■3RZ-FE ENGINE

1. General

258CO02

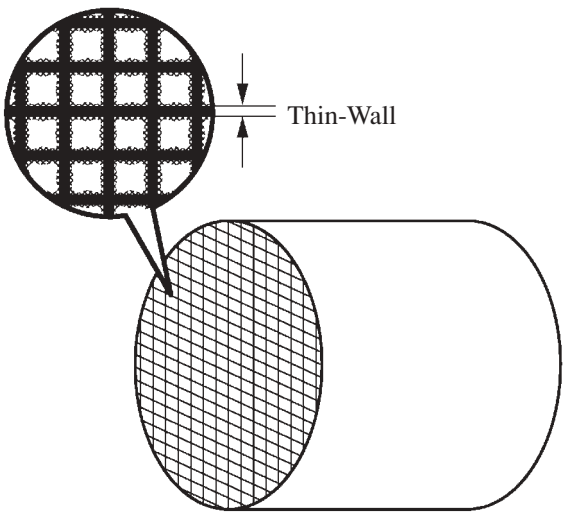
- The engine has been changed to the unleaded gasoline type.
- A thin-wall, ceramic type TWC has been adopted.
- One oxygen sensor has been newly provided in front of the TWC in order to improve the exhaust reduction performance of the TWC through feedback control to the engine ECU.
